# PERMIT

SEWAGE DISPOSAL SYSTEM

ADDRESS Route 144, Ellicott City, Md. PHONE 465-6646

PROPERTY OWNER George J. Hennick

PERMIT CARD

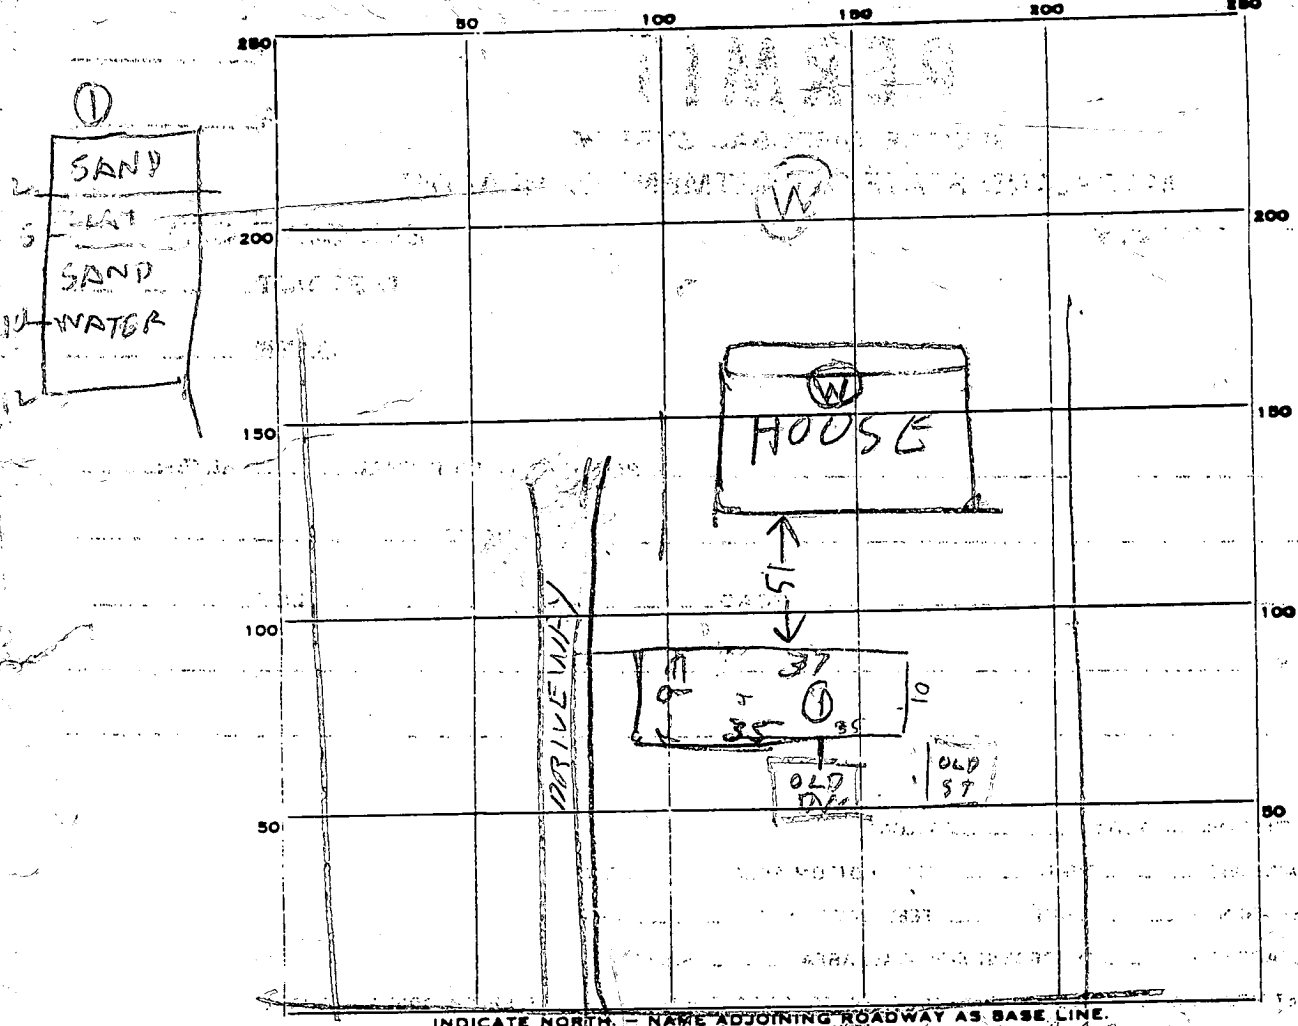
REMARKS 3/31/82 OLD DRY WELL OVERFLOWING AFTER 30 YEAR VISUAL

HOLE (W) DUG WATER 10 FT BGS. REQUIRED L.P. SEE SPECS (RH)

3/31/82 BED DUG & STONE ADDED

ONE CORNER OF BED DUG OUT FOR DEPTH MEASUREMENT. WELL INSIDE OF HOUSE NEAR BACK WALL RH

DATE SYSTEM APPROVED 3/31/82 INSPECTOR Raymond Hodges
